AVAILABILITY OF THE FINAL “FINDINGS OF FACT AND RECORD OF DECISION” DOCUMENT, WHICH IS PART OF THE ENVIRONMENTAL ASSESSMENT WORKSHEET FOR THE PILLSBURY A MILL COMPLEX

**FINAL FINDINGS OF FACT AND RECORD OF DECISION
ENVIRONMENTAL ASSESSMENT WORKSHEET
For the
Pillsbury A Mill Complex**

Located between Main Street and Second Street SE from Third Avenue SE to Fifth Avenue SE
and continuing along Main Street to Sixth Avenue SE., in the City of Minneapolis,
Hennepin County, Minnesota

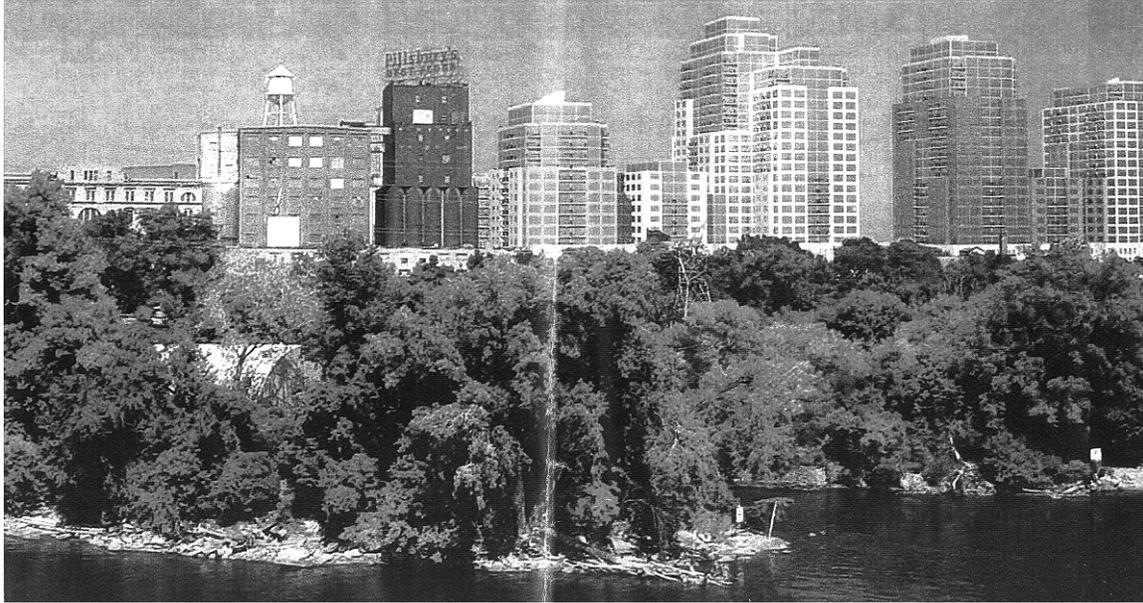
While the elevators extend horizontally for more than 400 feet along Second Street SE, new development extends for about 800 feet between the Red Tile Elevators and 6th Ave. SE along the Mississippi Riverfront (scale Fig. 13.1).

As can be seen from Proposer’s simulation, “3rd Avenue View,” unless one is viewing the development head on, the new buildings form a continuous visual wall, despite an intervening 5th Ave SE.

FIGURE 21.4
 Distribution of New Trips

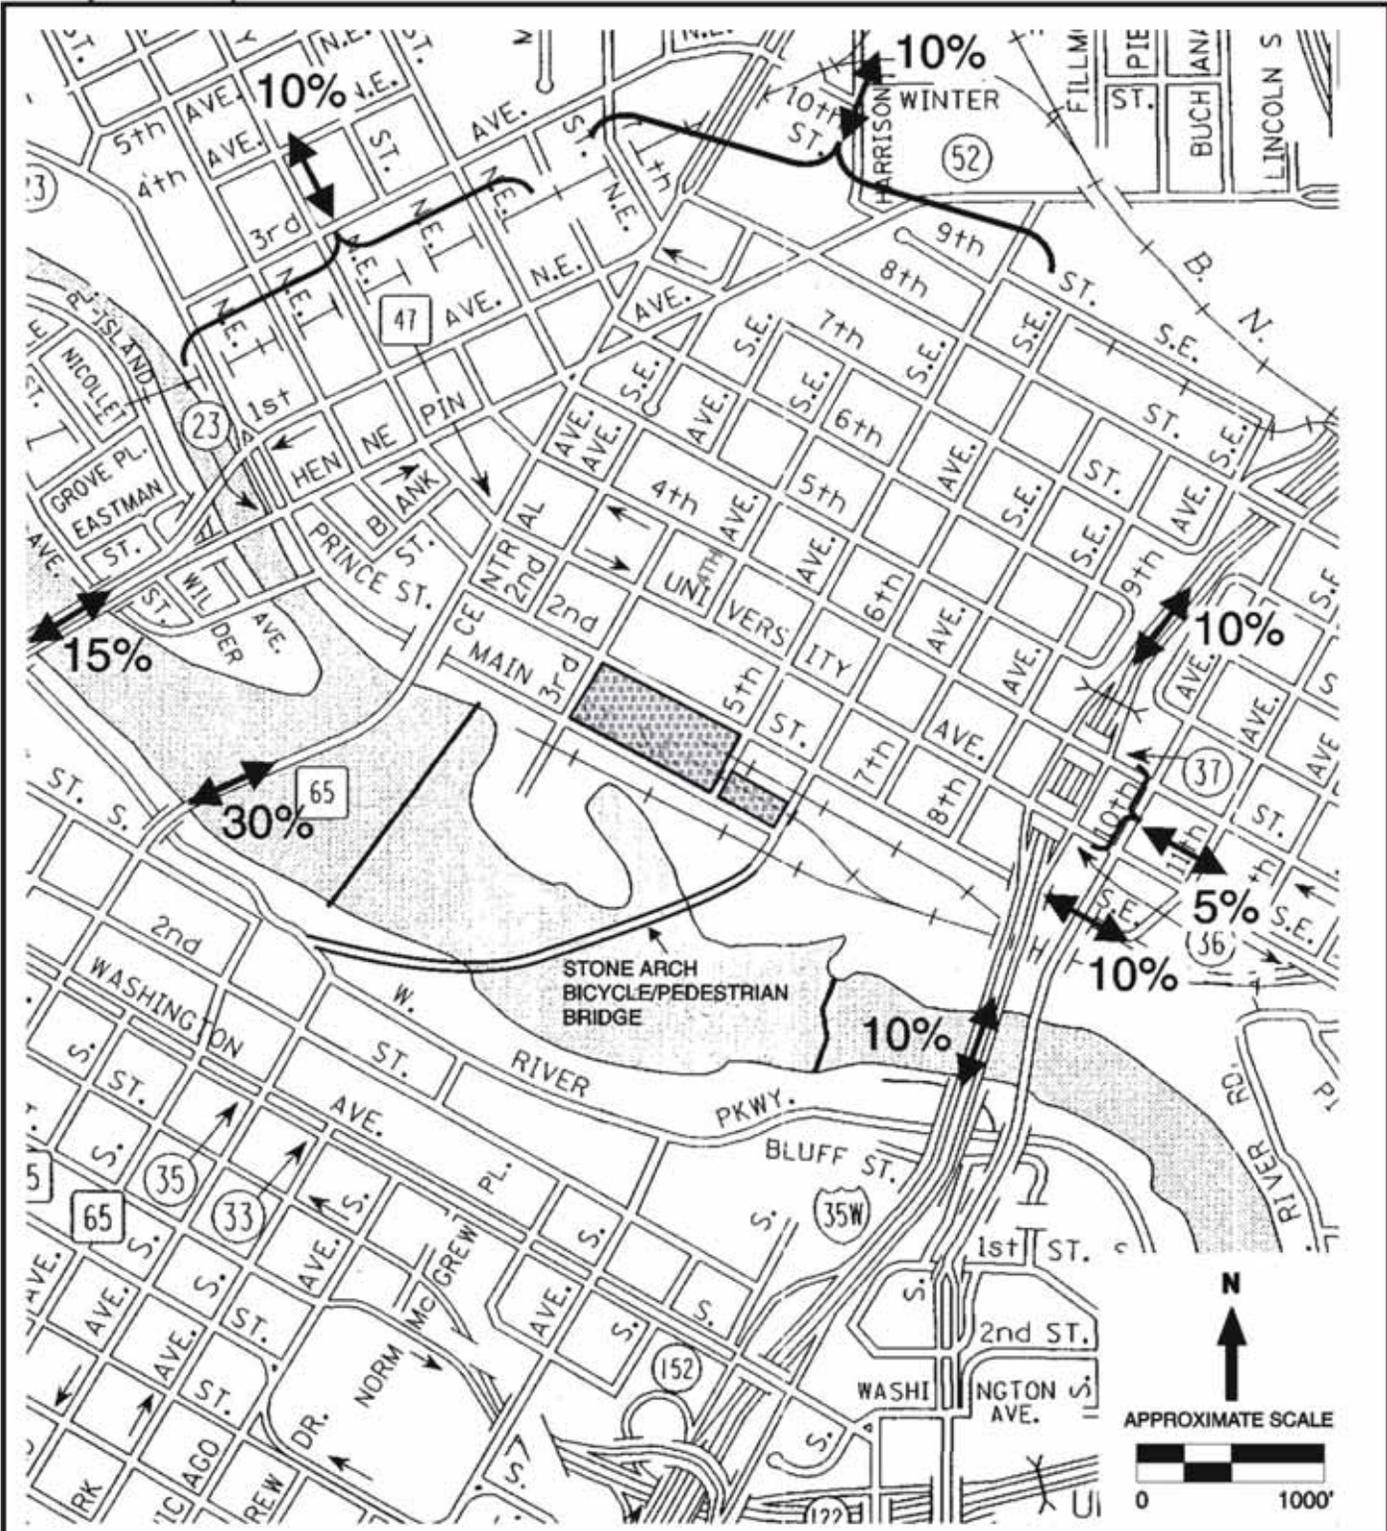
- The proposed development is projected to result in a significant number of vehicle trips in the area. Figure 21.4 estimates that 15% of these trips will be to and from the University area. It would therefore be desirable for the proposed development to participate financially in the community’s goal of completing the regional trail and road connection from Main Street along the river to the University and then to East River Parkway (commonly referred to as “the missing link”). Because of its proximity to both the East and West Bank campuses, the development will be an attractive place for University staff and students to live. Completing the trail and road/parkway connection will encourage walking and biking between the development and the University and could help reduce the projected amount of vehicular traffic. A safe and convenient connection could also result in university community providing a significant number of customers for the proposed retail portion of the development.

7. The Marcy-Holmes Neighborhood Association disagrees with the proposed distribution of new trips as shown on Figure 21.4. This figure shows only 35% of trips going to or from the east, to/from I-35W, I-94 Westbound, I-94 Eastbound via University Avenue SE, or the University of Minnesota. These are the access points to the regional roadway and a regional employer. We feel no less than 45% of trips should be distributed to/from the east. The 45% of trips to or from downtown via 3rd Avenue Bridge or Hennepin Avenue Bridge seems to be appropriate. Trips to and from the northeast and northwest seem too high and could be reduced
